VARIANCE APPLICATION

308 MADISON – STREAM BUFFER VARIANCE REQUEST

RE: 308 Madison Avenue – Stream Buffer Setback Area Variance Application

survey showing proposed work (zoomed in)

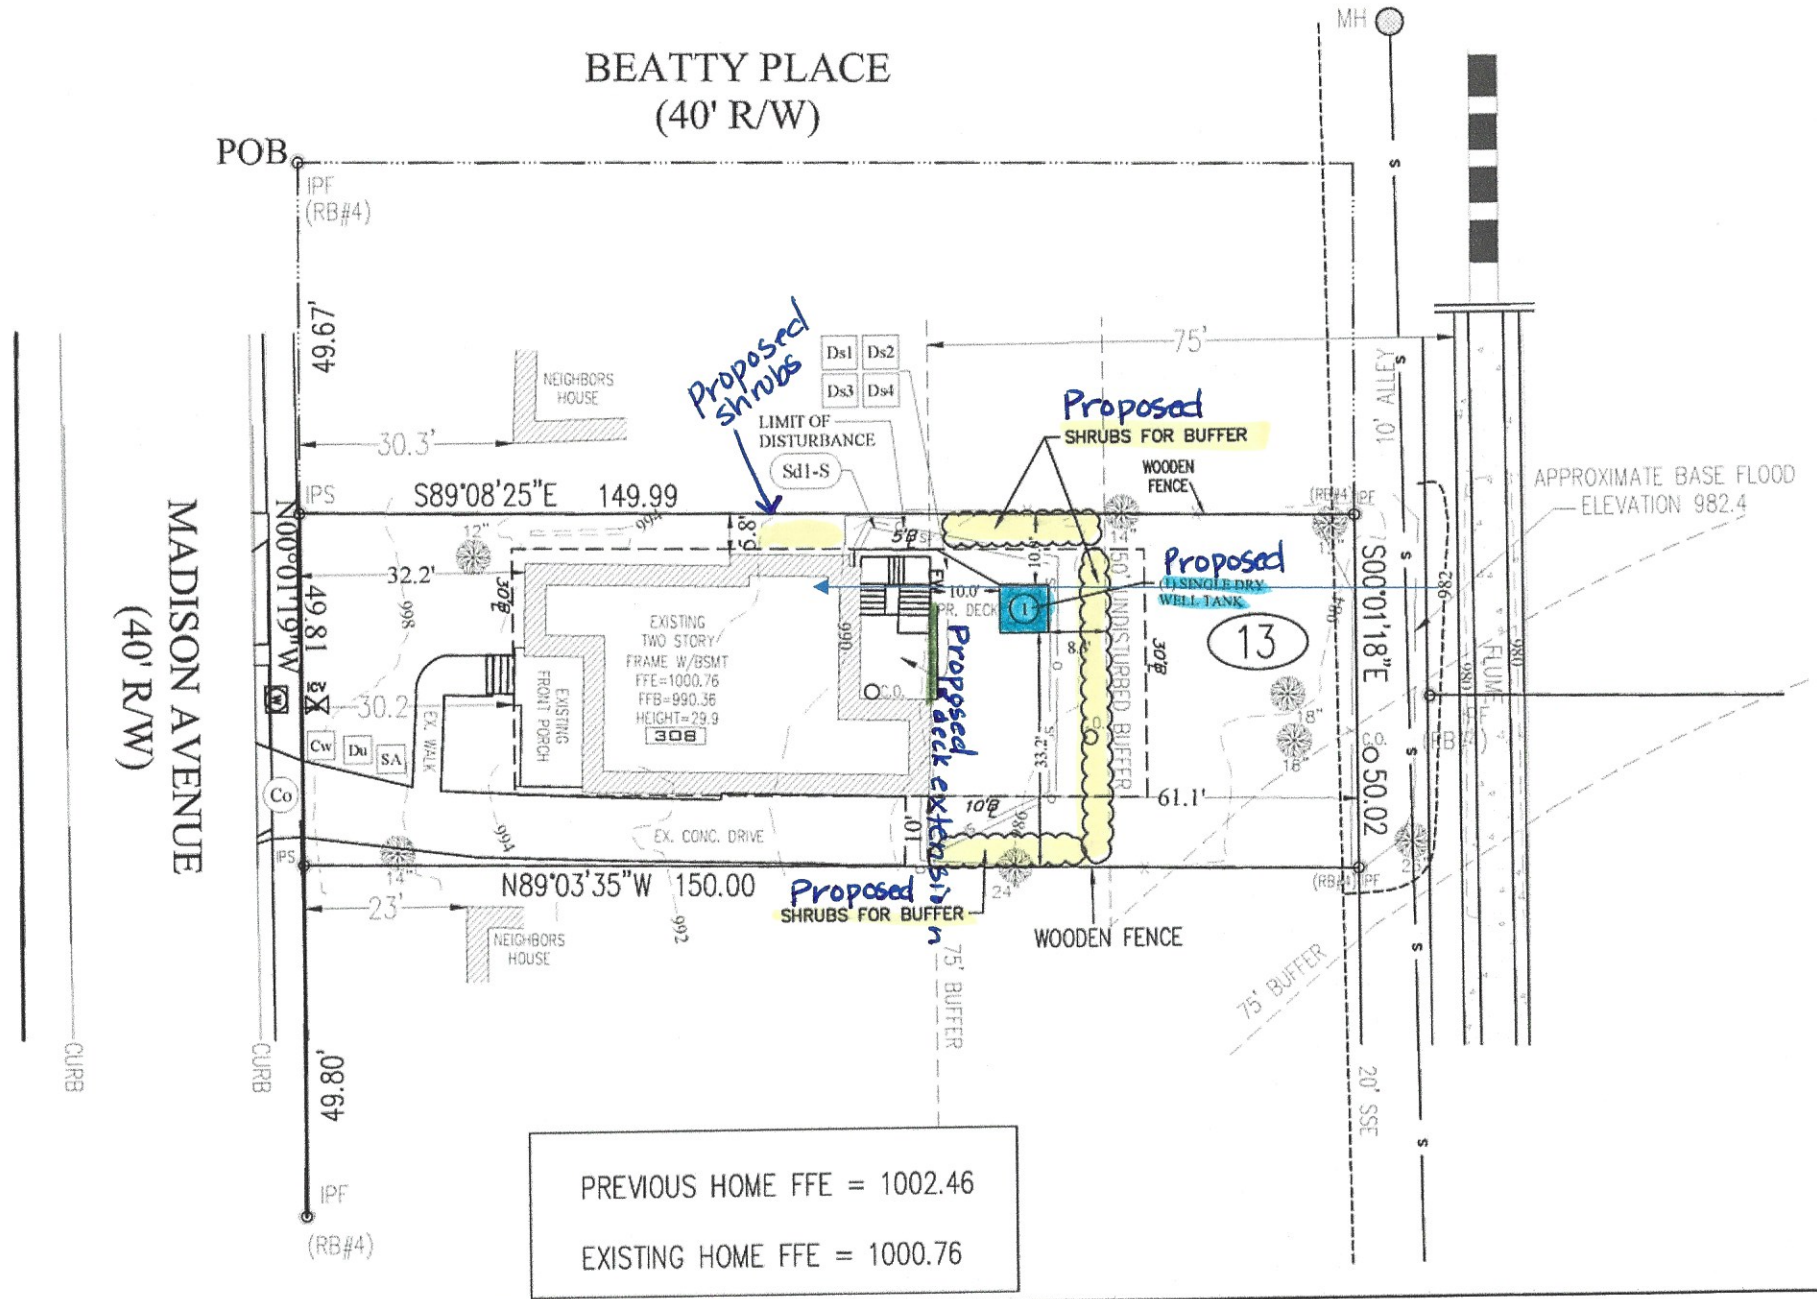
1. The proposed development requires a variance under Section 9.2 of the Stream Buffer Protection Ordinance due to encroachment into a 75 foot City Buffer Setback of the Sugar Creek Tributary that is east of the subject property.

8. The location of the proposed intrusion into the Stream Buffer Setback area, as shown on the Site Plan is a primarily over a developed grass rear yard.

9. Alternative designs for the proposed addition does not appear possible to eliminate the encroachment into the Stream Buffer Setback. With the overall additions of impervious areas within the Stream Buffer Setback area draining across vegetated areas, the proposed development will permit mitigation tasks to be performed. This proposal may be as protective of the natural resources and the environment as the existing developed conditions if no further disturbance is permitted.

- A. The Applicant shall prepare a Site, Vegetative Mitigation Plan and Soil Erosion and Sediment Control Plan and make a submission, along with a Site Development application and a \$100 application fee, to the Design, Environment & Construction Division that shall incorporate the following components:

1. The plan set shall contain a Soil Erosion and Sedimentation Control Plan prepared by a State certified professional that complies with the City and State Codes. The plan must document what Best Management Practices (BMPs) will be required along the perimeter of the area of disturbance approved by the Board to ensure the protection of Sugar Creek Tributary until permanent site stabilization has been established in accordance with the requirements of the Manual for Erosion and Sediment Control in Georgia. Due to the presence of State Waters, the silt fence BMP will need to be a double, not single row, as required by the State.

2. The Mitigation Plan shall indicate that the area immediately adjacent to, and downhill of, the structure shall be used to create a 10 foot wide intercept and filtering zone (Rain Garden) parallel to the Stream Buffer. This zone will be located such that runoff from the proposed new and replaced impervious surface within the buffer will drain through this zone and it will be planted to the Rain Garden standards established by the City of Decatur Streambank Restoration Plan List & Rain Garden Instructions and the guidance standards contained in the attached publication from the Atlanta Regional Commission's Clean Water Campaign entitled "Rain Gardens for Home Landscapes". The plan shall contain a plant list, planting layout with plant spacing and count, and a cross-section of the infiltration zone berm showing a ponding depth of six (6) inches to permit review, approval and inspection of the completed Rain Garden.
